IDAP REPORT

Property:	20 Karuah Street, Strathfield Lot: 188 DP: 15259 DA2022/81
Proposal:	Demolition of existing structures and construction of a two (2) storey dwelling with basement, swimming pool and associated works.
Applicant:	A Wu
Owner:	Mr Xuan Luo
Date of lodgement:	26 April 2022
Notification period:	10 May 2022 – 24 May 2022
Submissions received:	2
Assessment officer:	W van Wyk
Estimated cost of works:	\$1,583,094.00
Zoning:	R2-Low Density Residential
Heritage:	No
Flood affected:	No
Is a Clause 4.6 Variation Proposed:	No
RECOMMENDATION OF OFFICER:	REFUSAL

Figure 15: Final proposed driveway option, which was found to still adversely impact the neighbouring Jacaranda Tree

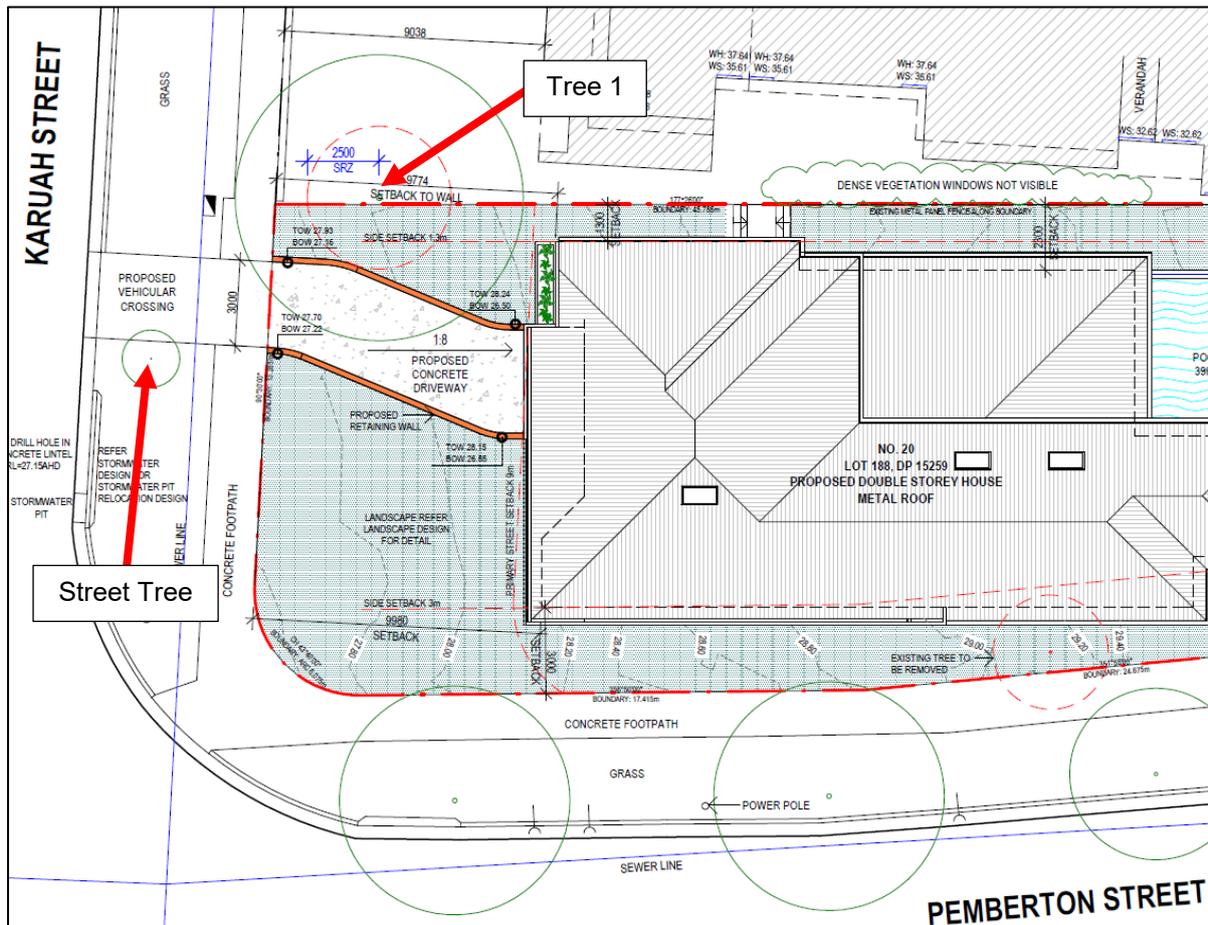
This additional information was requested on 2 June 2022 and 8 July 2022 and provided on 17 June 2022, 18 and 25 July 2022, and 8 August 2022. Council's Tree Management Coordinator found an unacceptable impact on the neighbouring Jacaranda and would not accept a relocation of the driveway towards the west as this would result in the loss of the street tree. An assessment of the final design option concluded:

Given that the neighbouring tree is likely to be placed at 'risk of critical impact and likely destabilisation', Council cannot support this application.

We can also not support the moving of the street tree located next to the driveway as this will place the tree in an undesirable location for the public. It will also effect the storm water drain and impact drivers line of sight if placed closer to the corner of Karuah Street and Pemberton Street.

There is a reasonable expectation of access to a residential site. The applicant is advised to explore alternative access options utilising the existing crossover on Pemberton Street. Due to the presence of Trees 5 and 6 in the rear yard, it may be that excavation to a basement is not possible. A basement is not a development right and can only be included where the site constraints permit.

Figure 17: Section B Showing Front Height Calculations

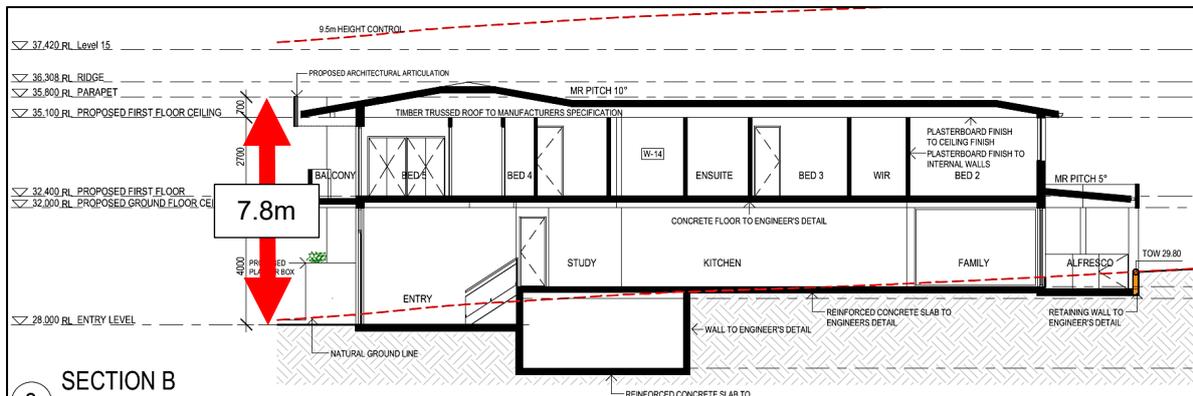
The building will have a flat roof appearance with a parapet at the street frontage. This will provide a total height of 7.8m (above the proposed ground level) with a parapet height of 0.7m, which complies with the SDCPC 2005 provisions (see **Figure 17**). The parapet was reduced by 0.67m as part of the amended plans requested by Council.

Figure 18: East Elevation Showing External Wall Height

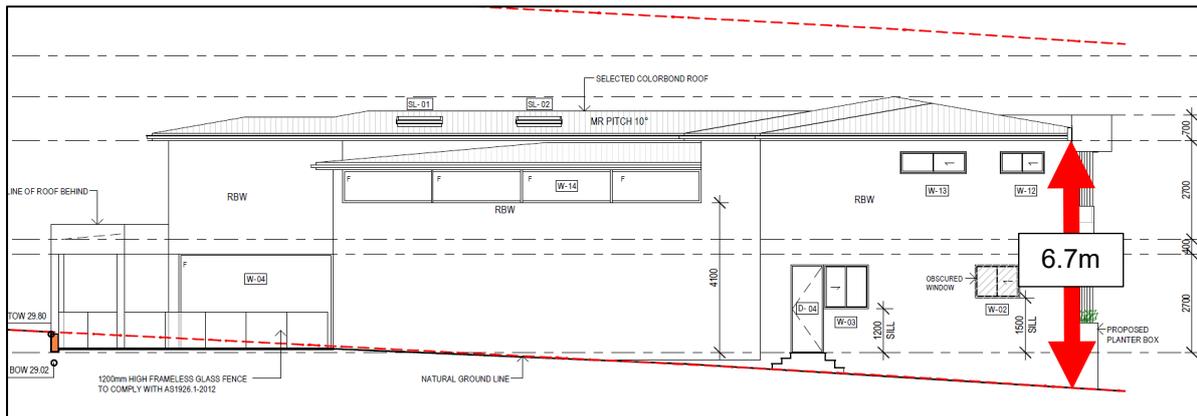
The maximum external wall height to the underside of the eaves is measured at the base of the highlight window of the East Elevation as 6.7m, complying with the 7.2m control (see **Figure 18**).

Figure 19: Section Showing Entry Ceiling Height

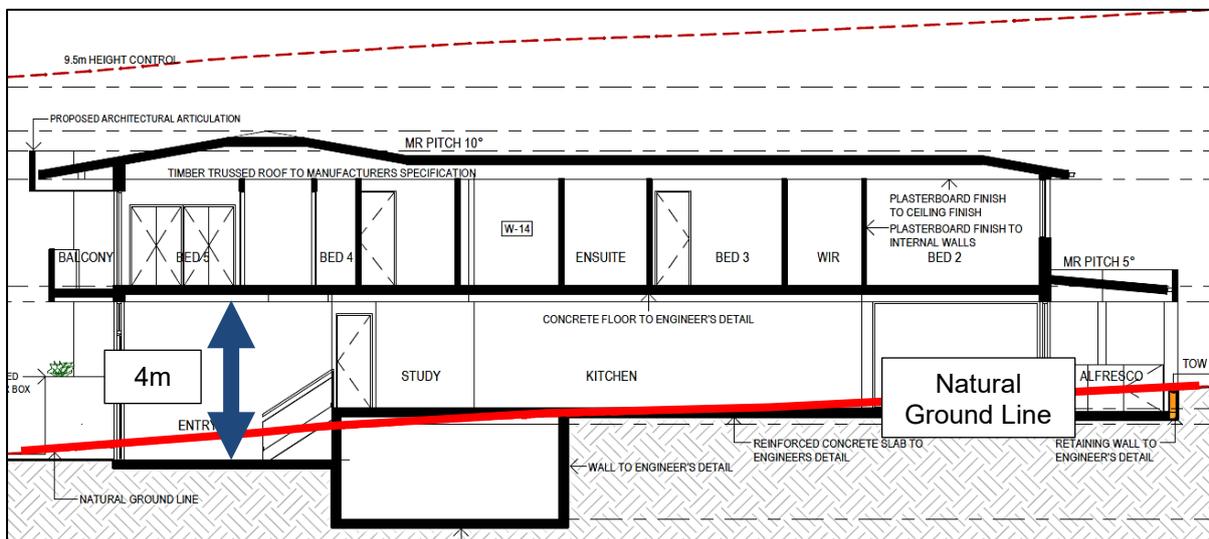
The proposal generally provides 2.7m floor to ceiling heights which easily comply with the 3m maximum control. However, the entry/lounge room and the void above the living/dining room do not comply.

The entry ceiling height reaches 4m, however this primarily a function of the underlying topography which slopes down in the north western corner (see **Figure 19**). The entry ceiling height was reduced by 0.1m as part of the changes made at the request of Council. This ensures the basement does not protrude more than 1m above the ground level. The increased floor to ceiling height allows for a consistent first floor level which improves access and amenity. This area remains compliant with the wall and building height provisions and will not significantly contribute to the perceived bulk. Accordingly, the non-compliance is considered acceptable in this instance.

Figure 20: Ground Floor Plan Showing Location of the Void

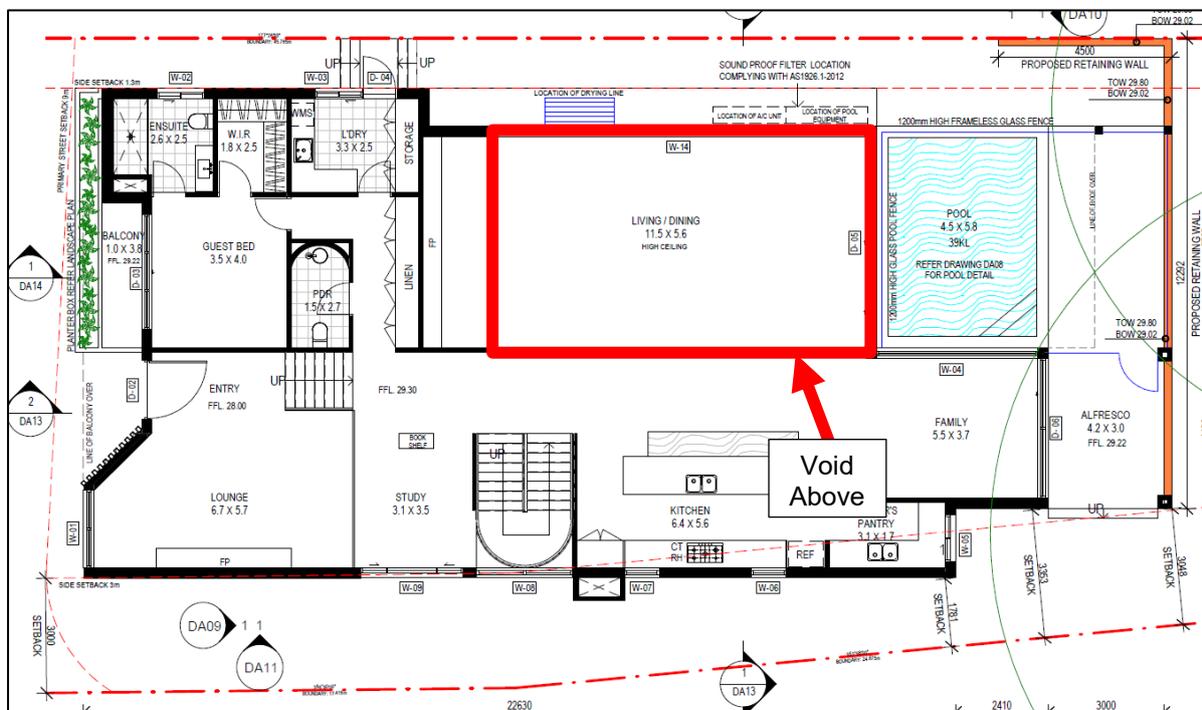
The void above the living/dining area results in a floor to ceiling height of 5m (see **Figures 20 and 21**). This has been reduced by 0.8m from the originally submitted design. The objectives of the height provisions of the SDCDP 2005 are as follows:

The proposed void area is located near the rear of the dwelling where it will not be readily visible from the public domain. Accordingly, it will not materially impact the character of the area nor impact any potential view corridors. The void has been reduced at the request of Council and now presents as an articulated element. The highlight windows were originally proposed to provide natural light to the first floor corridor. After the void height was reduced, skylights were incorporated to ensure natural light was retained.

Figure 21: Section Showing Living/Dining Room Void

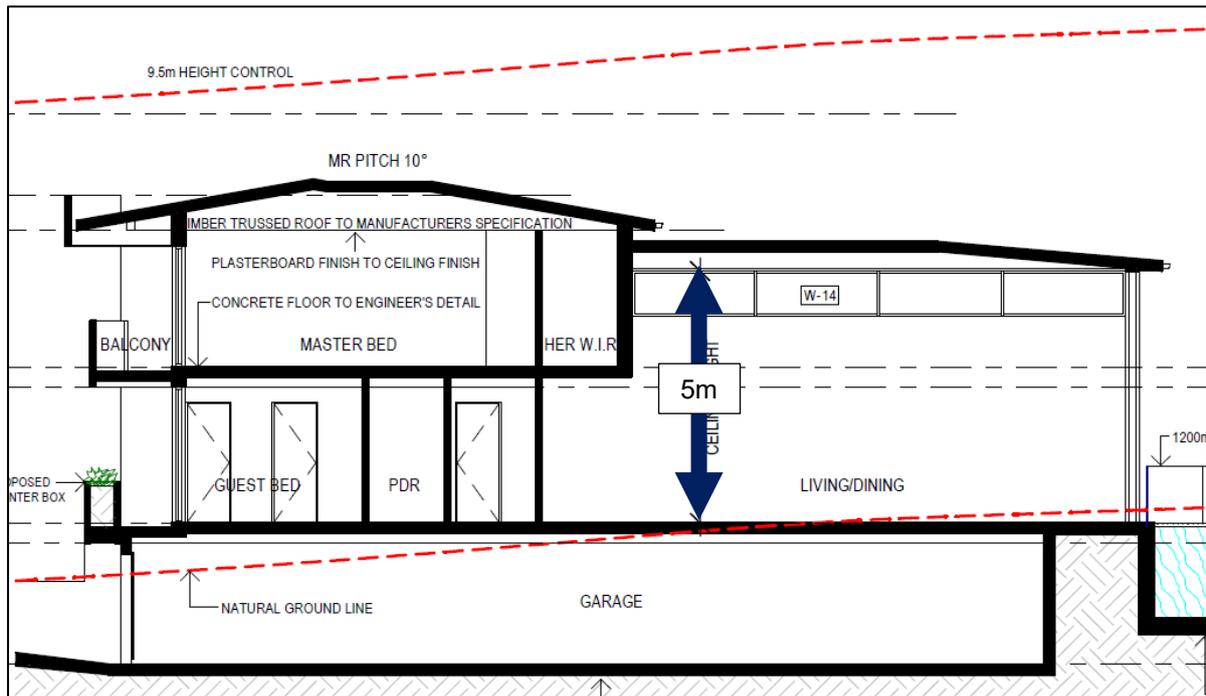
Although the void does not contribute to GFA, a relevant consideration is whether the built form could have been improved if upper level GFA was relocated to the location of the void. This would not be appropriate in the circumstances of this particular case given the only adjoining dwelling is to the east and therefore the habitable floor space would have, in any event, remained massed towards the west. This is also not a fair comparison given the height of the void has been reduced such that it is insufficient to act as habitable floor area.

Figure 22: Root Mapping Report Demonstrating Impacts on Structural Root of the Jacaranda by the Single Width Basement Driveway

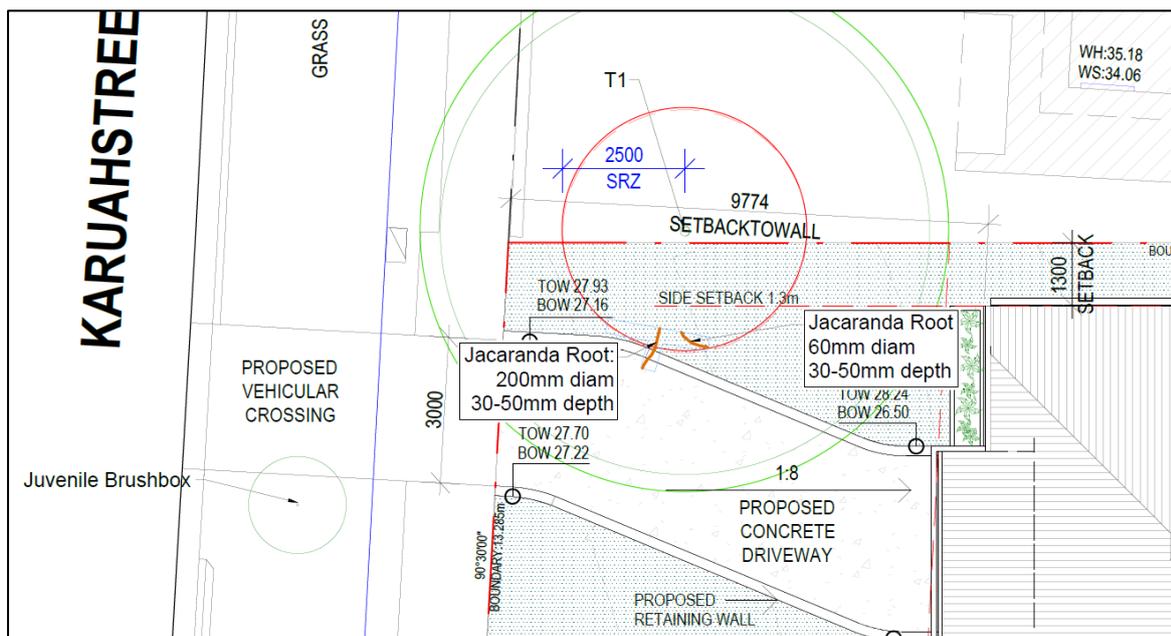
Similarly, there cannot be significant impacts on neighbouring trees. The Tree Root Mapping provided on 8 August 2022 demonstrated that even the reduced driveway layout would catastrophically impact this tree (see **Figure 22**). The application cannot be approved with the driveway access proposed.

Figure 23: Proposed Front Fencing along Karuah Street

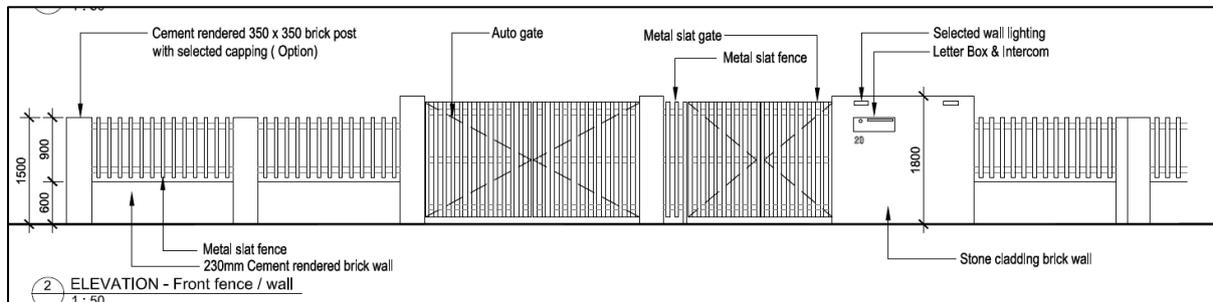
The proposed front fence is generally at 1.5m which complies with the SCDCP 2005 provision. However, there is a 1.8m solid component adjoining the vehicular entry gate (see **Figure 23**). This will be reduced down to 1.5m to match the rest of the fence line and forms a reason for refusal.

Figure 25: 3pm Shadow Diagram on the Winter Solstice with the Additional Shadow Generated by the Void Outlined in Red

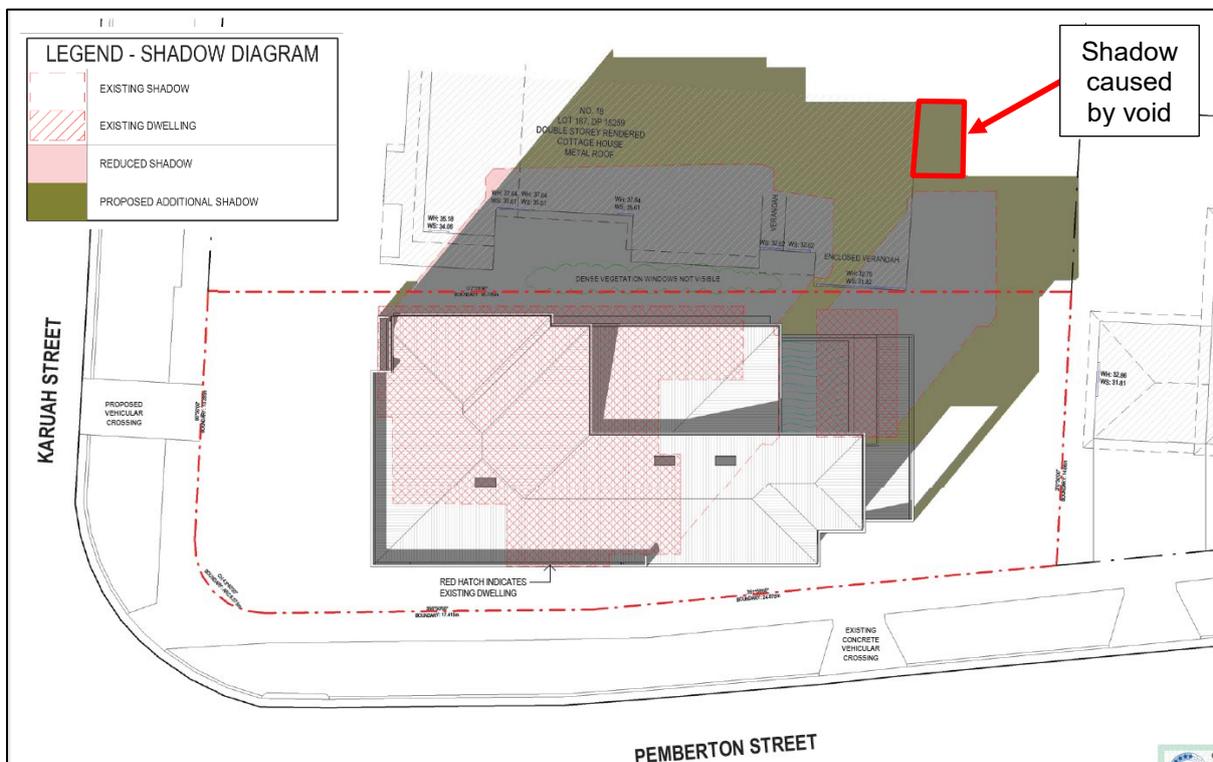
After a request from Council, the applicant amended the design to reduce the void component. This assisted in minimising overshadowing. The only additional overshadowing from the void component onto the rear yard of 18 Karuah Street is at 3pm and covers an area of approximately 4.5m² (see **Figure 25**). The rear yard of 18 Karuah Street is in the order of 147m² and this minor additional overshadowing for a small period of the day will not be readily noticeable.
